# 1990 Corvette: Service Bulletin: L98 and LT5: Revised Air Conditioning Control Circuit Diagnosis

**Subject:** REVISED AIR CONDITIONING CONTROL CIRCUIT DIAGNOSIS

**Model and Year:** 1990 CORVETTE WITH 5.7L L98 AND LT5 ENGINES

**Bulletin Number:** 90-400-6E

**CHART C-10**

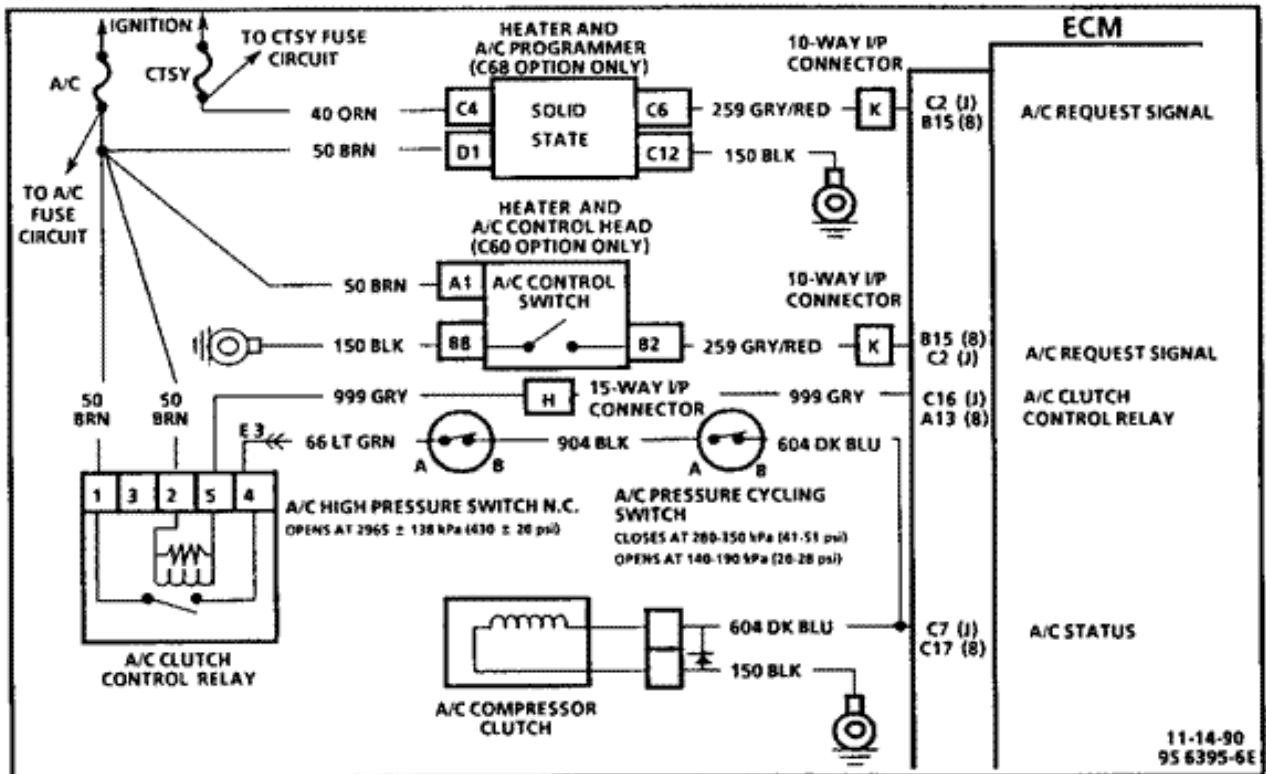
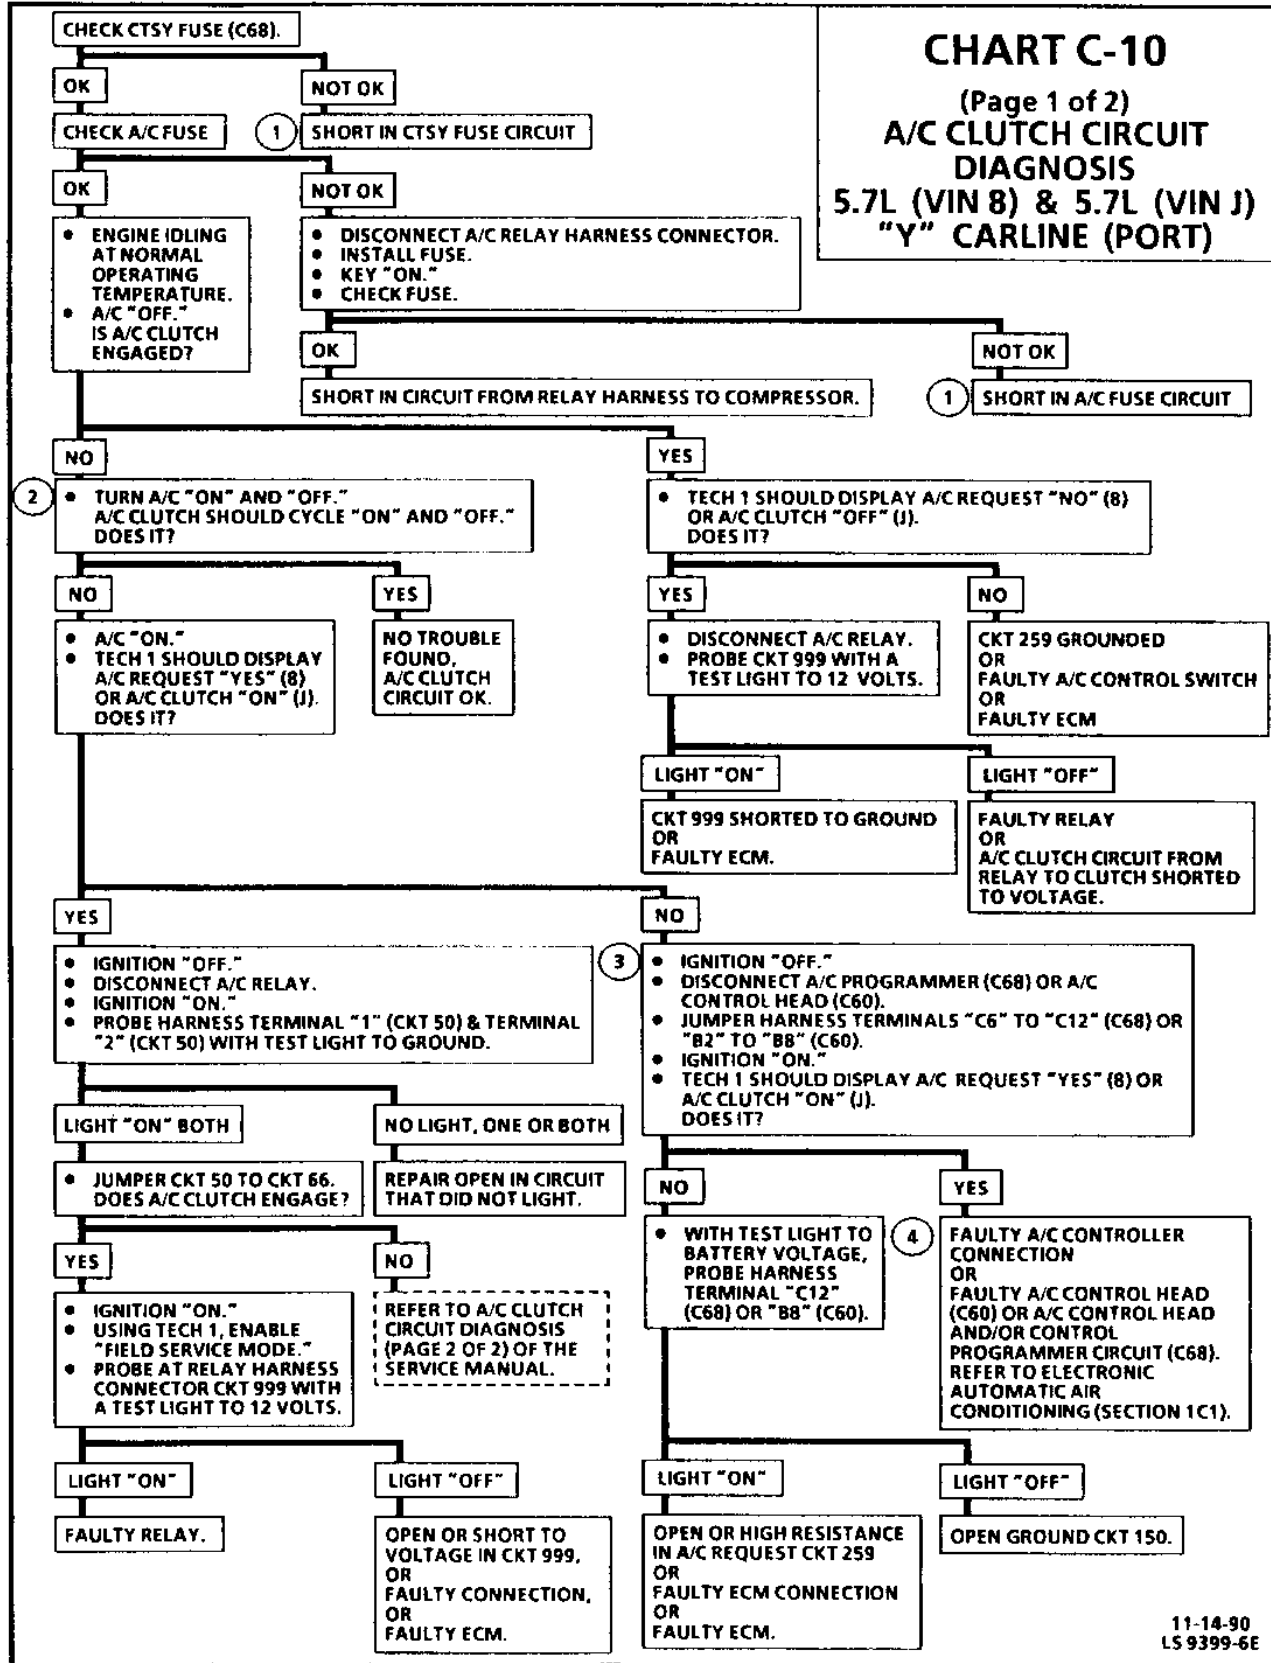
The following information updates the A/C clutch circuit diagnostic chart and facing page information found on pages 6E3-C10-4 and 6E3-C10-5 in Section 6E3 "Driveability And Emissions" for the 1990 "Y" 5.7L L98 (VIN 8) and LT5 (VIN J) Corvette Service Manual.

The A/C clutch control relay is ECM controlled to delay A/C clutch engagement after

the A/C is turned "ON." This allows the ECM to adjust engine rpm before the A/C clutch engages.

The ECM will engage the A/C clutch any time A/C has been requested unless any of the following conditions exist.

- o High coolant temperature.
- o Wide open throttle.
- o High oil temperature.
- o Sustained high vehicle speeds (LT5).
- o High engine rpm.

The ECM can determine A/C request by sending a voltage signal to the A/C control head. When the A/C control switch is closed, the A/C request voltage signal is grounded. This is shown on the Tech 1 as A/C request "YES" (8) or A/C clutch "ON" (J).

When a request for A/C has been detected by the ECM, the ECM will ground the A/C clutch control relay drive circuit, the relay contacts will close and energize the compressor clutch portion of the circuit. If the system is properly charged, the circuit will be complete to the A/C compressor clutch.

When A/C request has been detected by the ECM, the cooling fan(s) will be turned "ON" unless vehicle speed is too high.

1. Refer to ELECTRICAL DIAGNOSIS (SECTION 8A) "FUSE BLOCK DETAILS" for fuse circuit power distribution.
2. Checks the ECM's ability to control the A/C clutch control relay.
3. Checks to determine if the ECM is capable of detecting the A/C request signal being grounded.
4. Before replacing C68 A/C control components," refer to ELECTRONIC AUTOMATIC AIR CONDITIONING (SECTION 1C1) for further A/C diagnostics.
